SPECIFIC REQUIREMENT'S (Section- Project)
C/ENGG/SPEC/SEC-PROJECT/SPECIFIC REQUIREMENT REV NO 10

Employer has standardized its Specific Requirement for various equipment and works for different voltage levels. Items or clauses, which are not applicable for the scope of this package as per schedule of quantities described in BPS or as per scope defined elsewhere in Section Project, the technical specification/clauses for the items specified below should not be referred to.

TYPICAL ARCHITECTURAL DRAWING OF SUBSTATION AUTOMATION SYSTEM (Without Process Bus) for New Substation

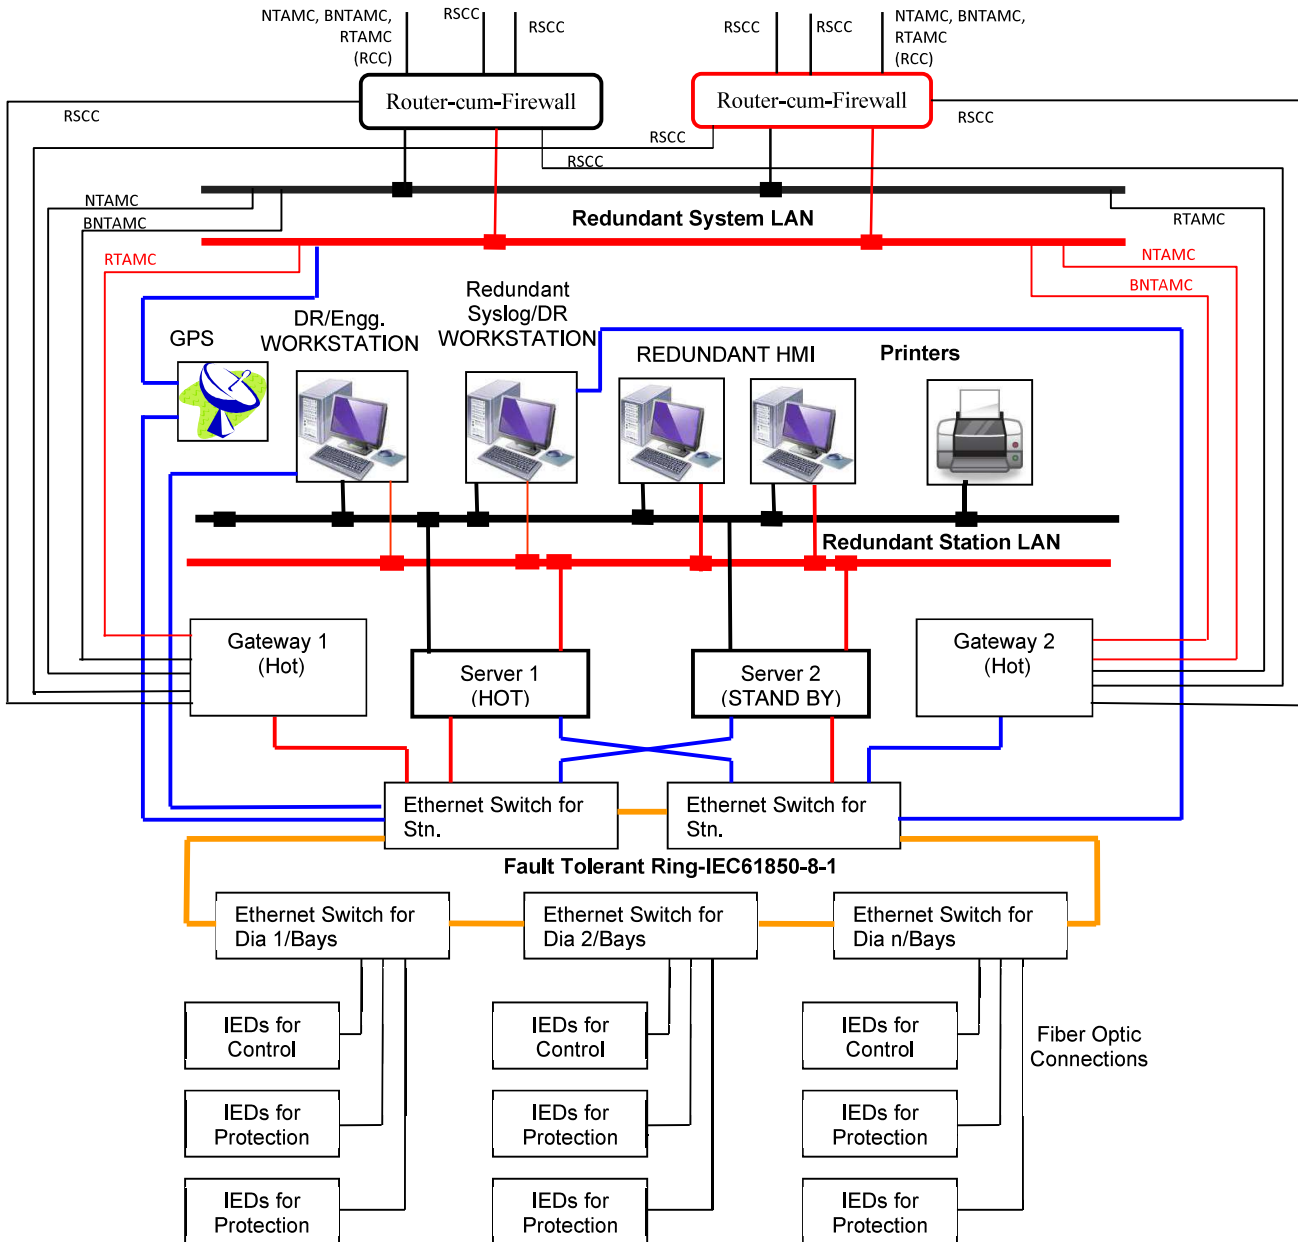
S.No.	Clause No.	Amended As (As per Specific Requirement Rev 10)
L.	Section SAS	Rev 04
1.	Typical Architectural Drawing of SAS (Without Process Bus)	TYPICAL ARCHITECTURAL DRAWING OF SUBSTATION AUTOMATION SYSTEM (Without Process Bus) stands replaced by <u>Annexure-S5</u>
